FINAL
MONITORING REPORT
YEAR 4 (2021)
MUD LICK CREEK MITIGATION SITE

NCDMS Project No. 93482

RE: Mud Lick Creek Monitoring (DMS Project # 93482, Contract #7683)
Final MY4 (2021) Annual Monitoring Report

FIGURE
2

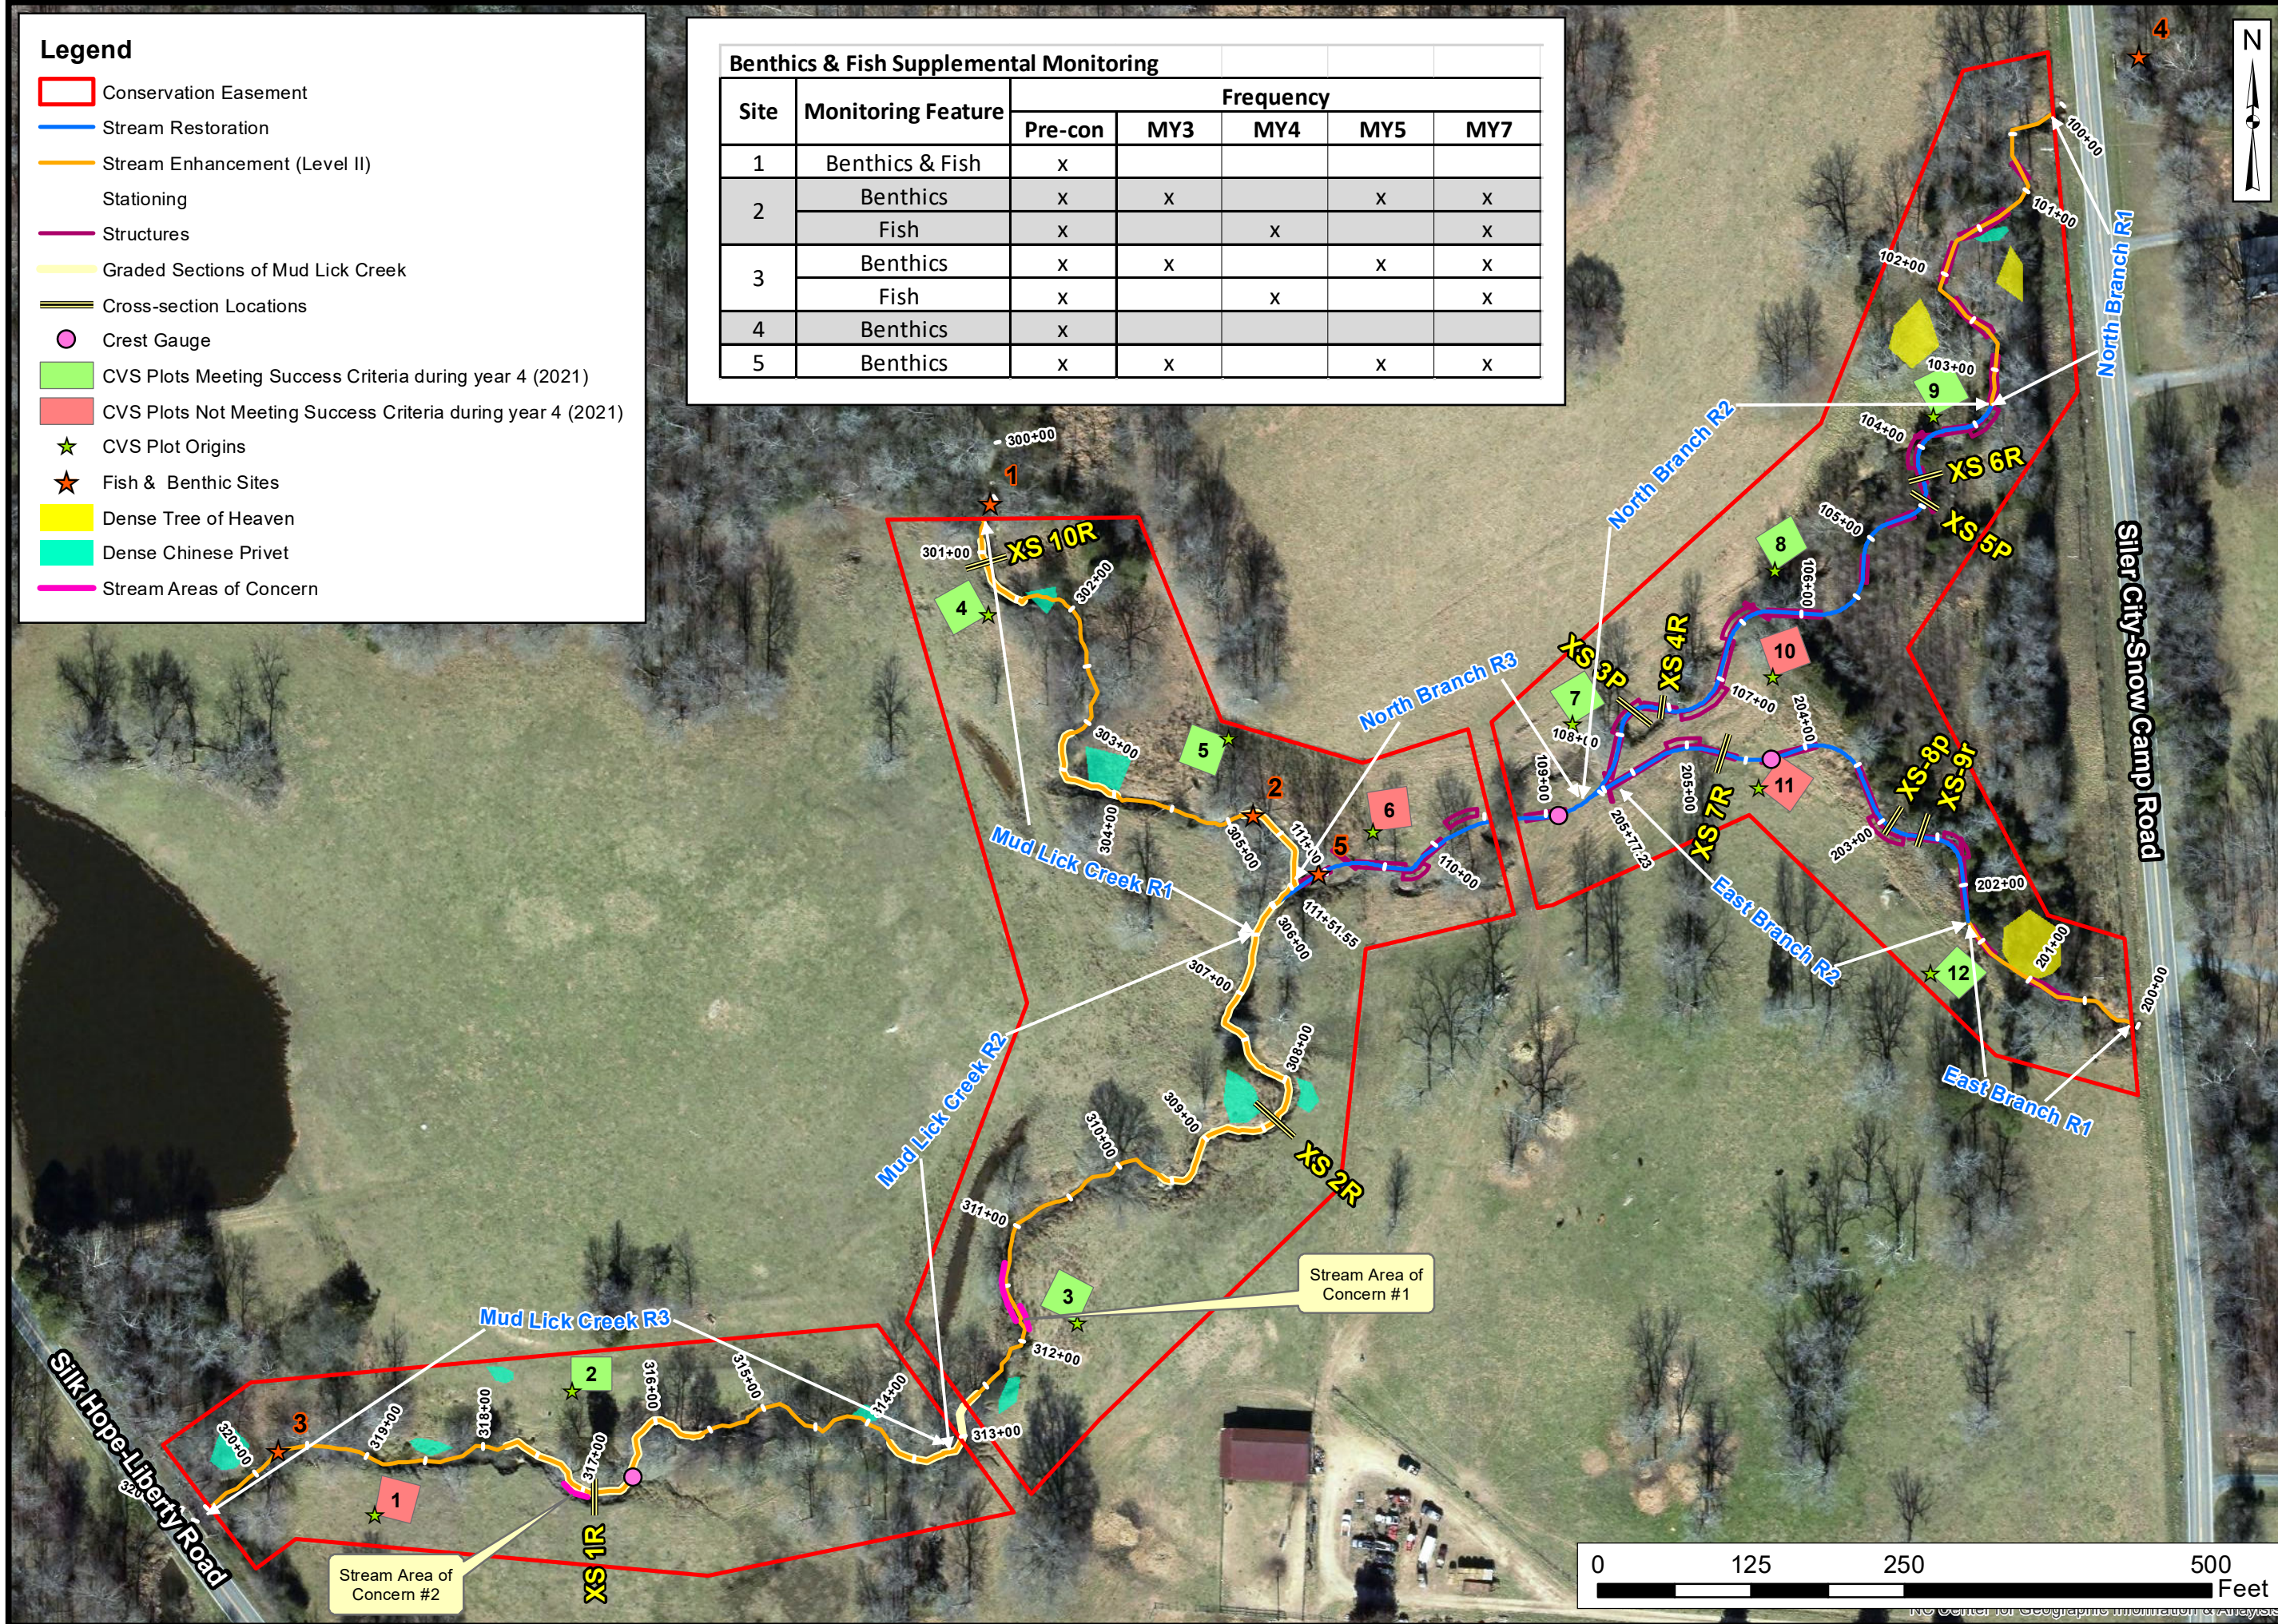
2. Please submit the stream areas of concern features as lines and ensure that these areas are reflected in Table 5.
A stream areas of concern line feature has been included in the digital submittal. These areas were not included on Table 5 due to the fact that they occur on Enhancement II reaches.

River Basin:	Cape Fear
Site Name	Mud Lick Creek
XS ID	XS - 3, Pool (North Branch)
Drainage Area (sq mi):	0.65
Date:	4/6/2021
Field Crew:	Adams, Lawson

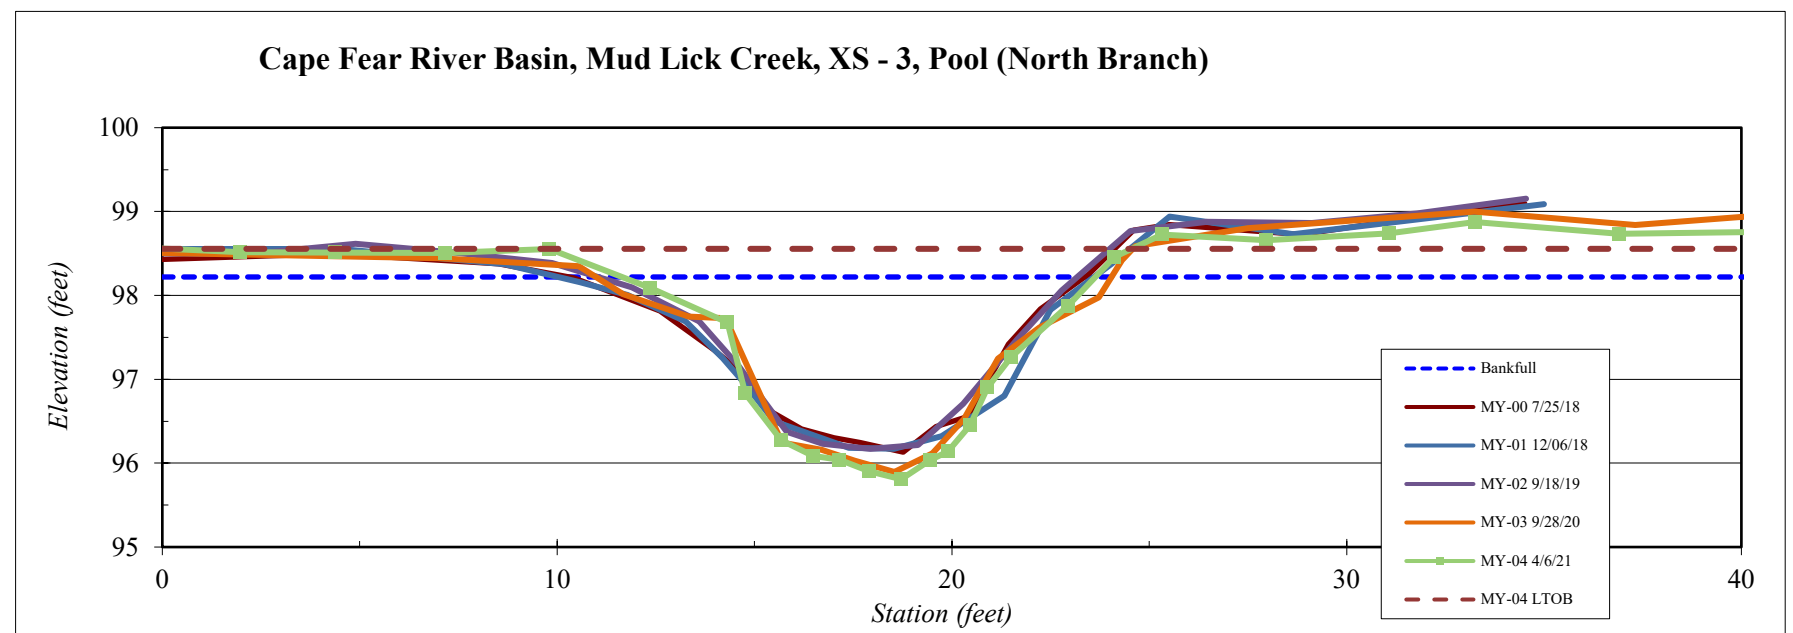
3. Please ensure that areas outside of the main channel (determined by the low bank height) are excluded from the cross sectional area calculation before the bankfull elevation is adjusted to achieve the MY0 cross sectional area. For example, XS-4 should have a BHR less than 1.0 when these points are excluded.
Areas outside the main channel were excluded from the cross-sectional areas prior to adjusting the bankfull elevation for all cross-sections. Cross-section 4 has a low bank height of 2.047941 and BF max depth of 2.063948, making its bank height ratio 0.99, which was rounded to 1.0.

4. We recommend removing the green dotted line on all cross sections. Also, it may make analysis easier to display the MY-04 LTOB as a line instead of a point. We also recommend not reporting BHR on pools, and we really only need to see LTOB identified on pool features.
The MY0 TOB line was removed from all cross-section figures. The MY-04 LTOB point was changed to a line. BHR values were removed from pool cross-sections.
